Unresolved from last review:

EDARP FILE NO.: PPR2332

PROJECT
8815 HOT MIX HEIGHTS
LOT 2, AMENDED PLAT BARBARICK SUBDIVISION
EL PASO COUNTY

DEVELOPMENT PLAN

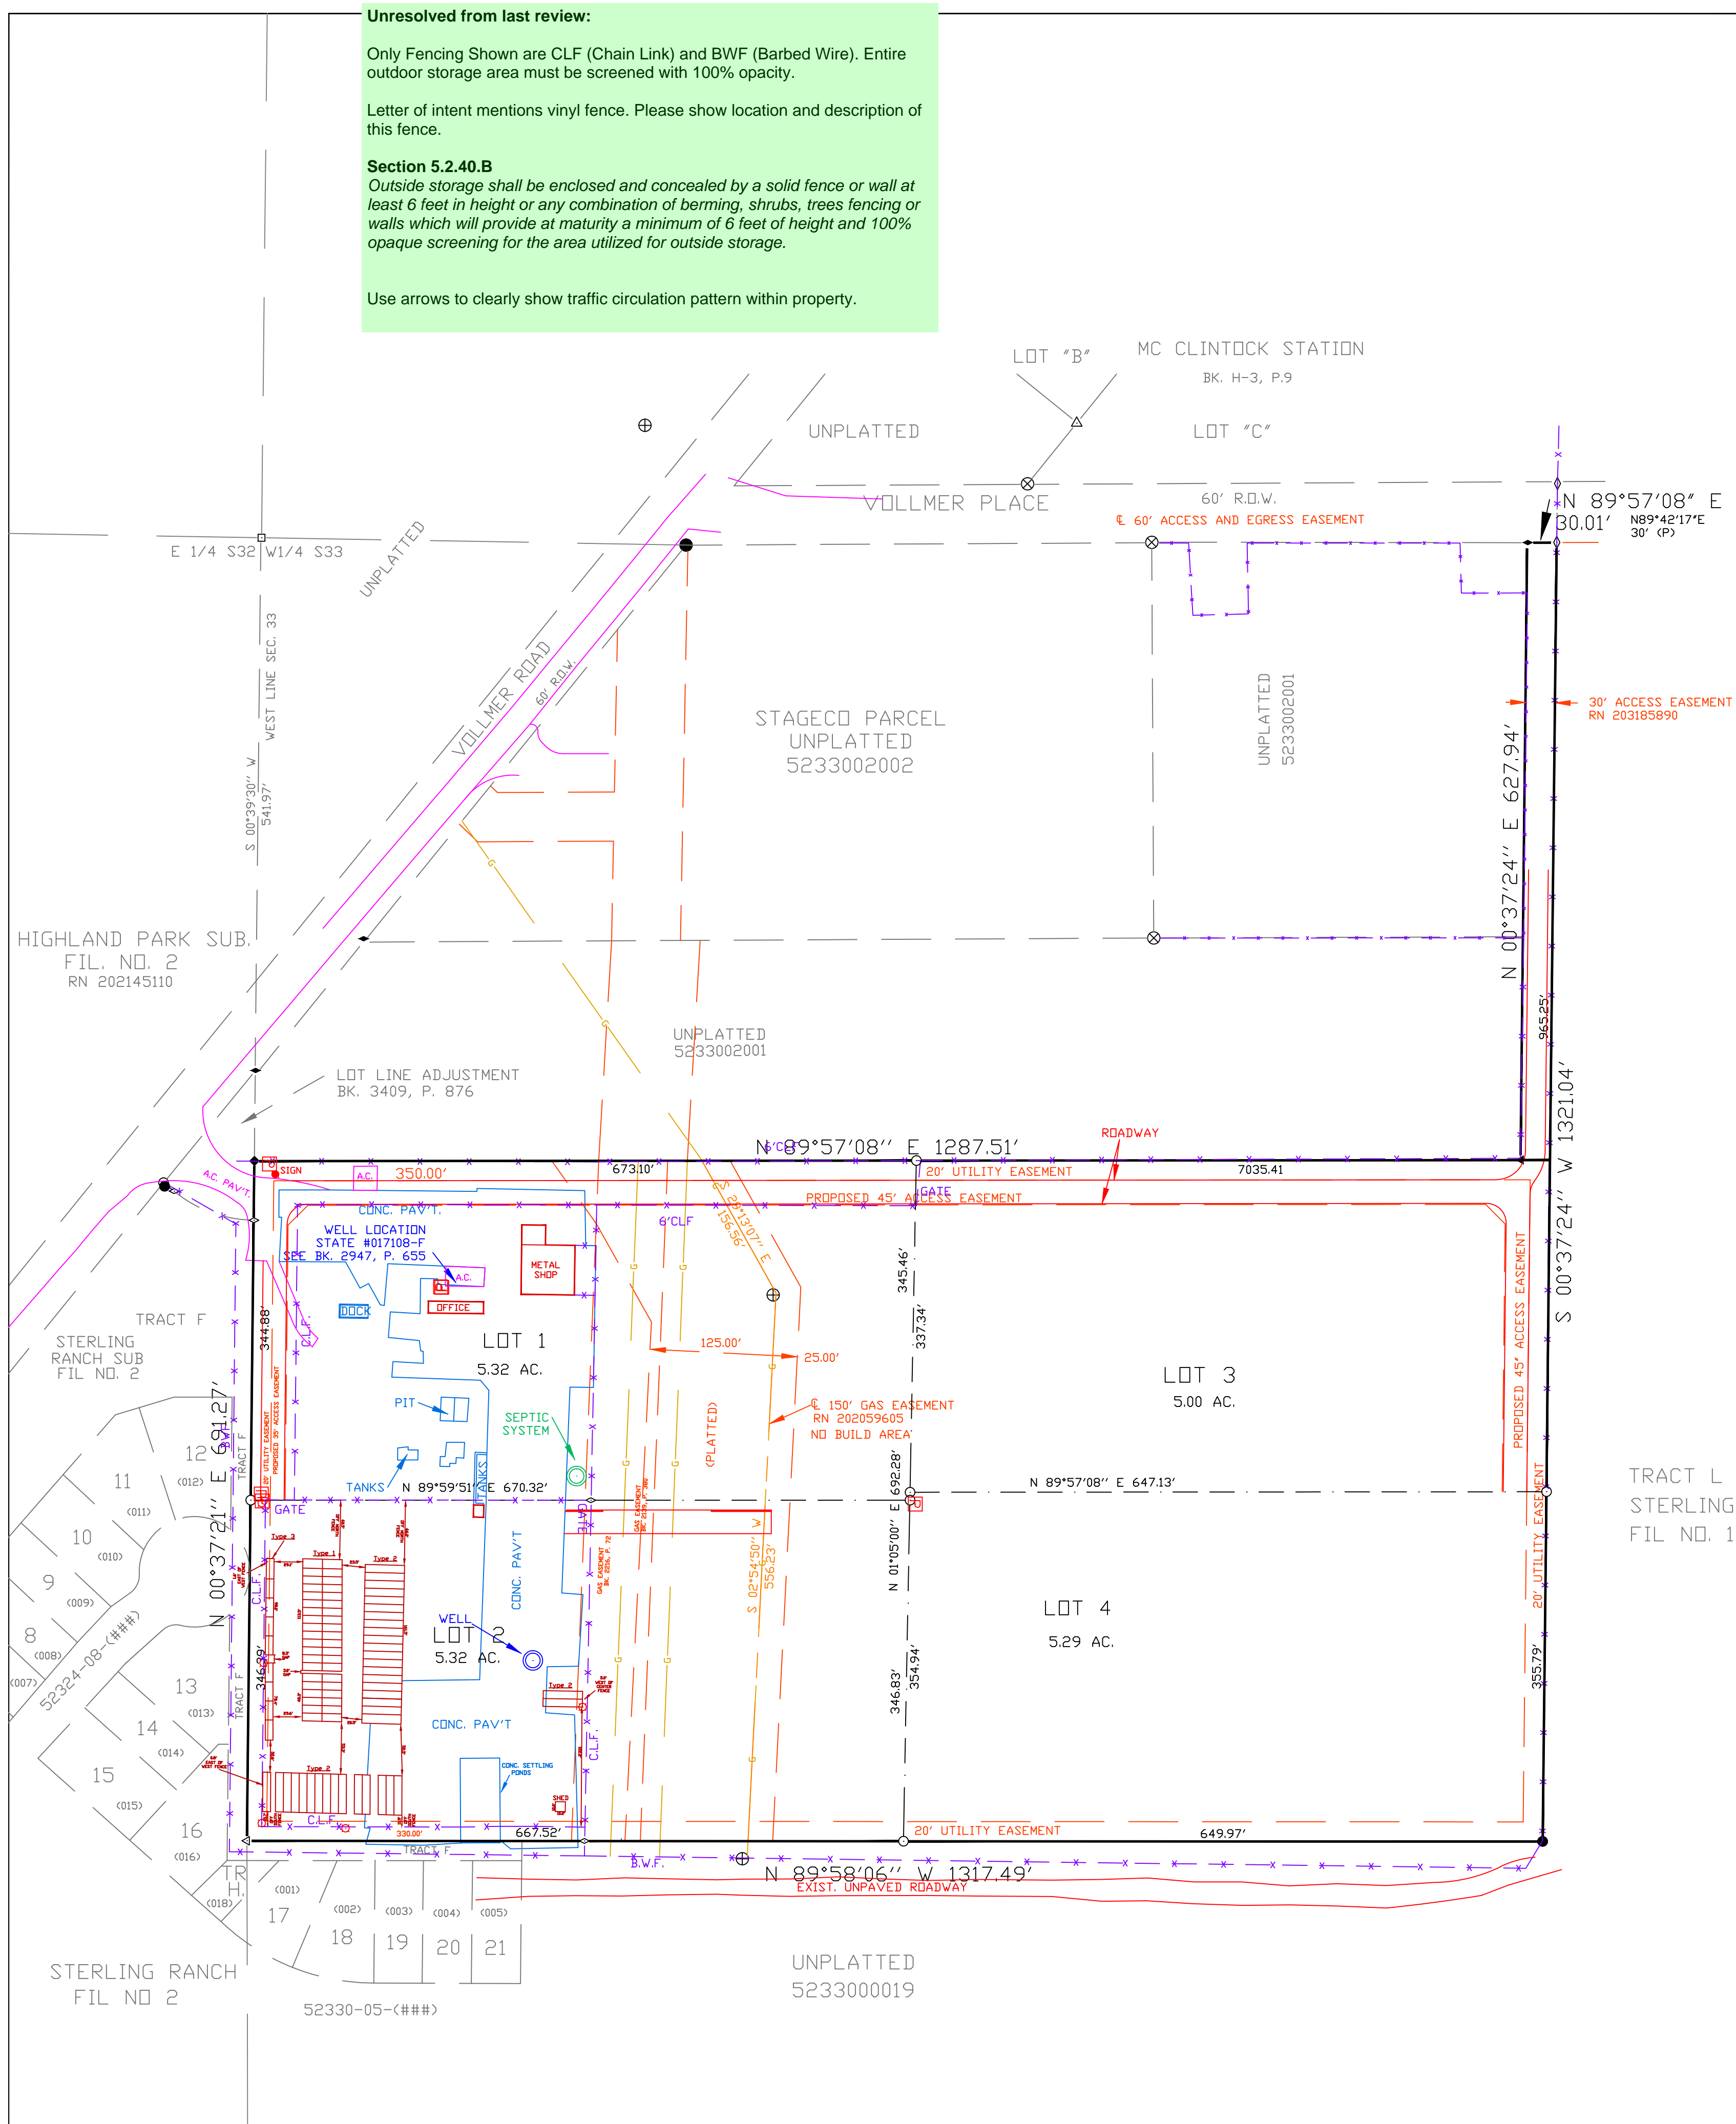
Only Fencing Shown are CLF (Chain Link) and BWF (Barbed Wire). Entire outdoor storage area must be screened with 100% opacity.

Letter of intent mentions vinyl fence. Please show location and description of this fence.

Section 5.2.40.B
 Outside storage shall be enclosed and concealed by a solid fence or wall at least 6 feet in height or any combination of berming, shrubs, trees fencing or walls which will provide at maturity a minimum of 6 feet of height and 100% opaque screening for the area utilized for outside storage.

Use arrows to clearly show traffic circulation pattern within property.
